Work Order ID 162224

Item Name: Replacement Skidtube (Fits LH or RH)

DRAWING NO. D2650	TITLE 206/407 SKIDTUBE ASSEMBLIES	REV. F	DART AEROSPACE LTD ENGINEERING ORDER		D.E.O. NO. D2650-F-1	SHEET NO. SHEET 1 OF 1	SCALE NTS
DRAWN <i>P</i>	CHECKED A.P.	MFG. APPR. <i>AA</i>	APPROVED <i>HA</i>		DE APPR. <i>HA</i>		
DATE 12.10.12	DATE 12.10.22	DATE 12.10.22	DATE 12.10.22		DATE 12.10.22

DETAIL B

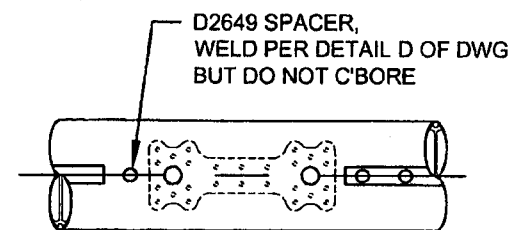
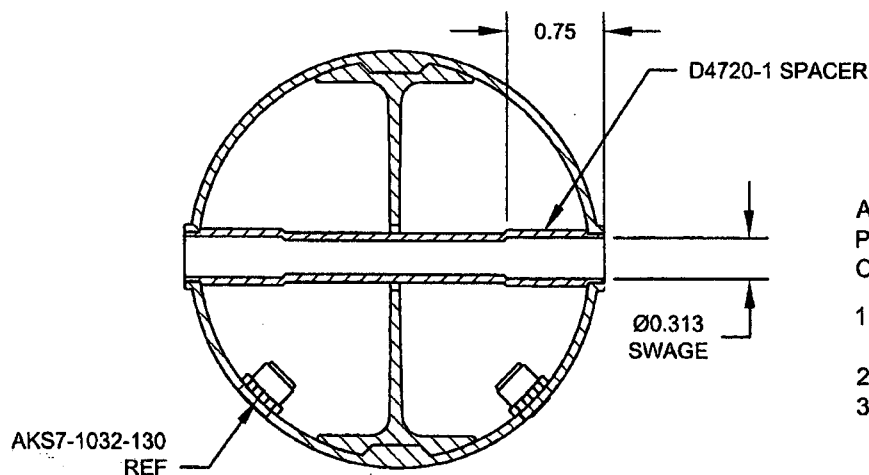
PURPOSE:

CHANGE C'BORED WELDED CROSSBOLT-SPACERS TO SWAGED SPACERS

ADD DETAIL G BELOW, WHICH IS THE SAME SECTION VIEW AS DETAIL D OF DWG.

C'BORED HOLES ARE NOW SWAGED PER DETAIL G BELOW. FOR THE Ø0.375 HOLE THAT IS NOT C'BORED, WELD PER DETAIL D OF DWG (SEE AMENDED DETAIL B FOR REFERENCE).

AFTER DRILLING AND BENDING ASSEMBLY
PERFORM THE FOLLOWING FOR Ø0.375 HOLES THAT ARE
CURRENTLY C'BORED:

1. INSERT D4720-1 SPACER, 16 PL (-1) OR 17 PL (-3)
OR 19 PL (-5) OR 23 PL (-7)
2. SWAGE TO Ø0.313 X 0.75 DP PER QSI 002
3. TRIM / GRIND FLUSH PER QSI 002
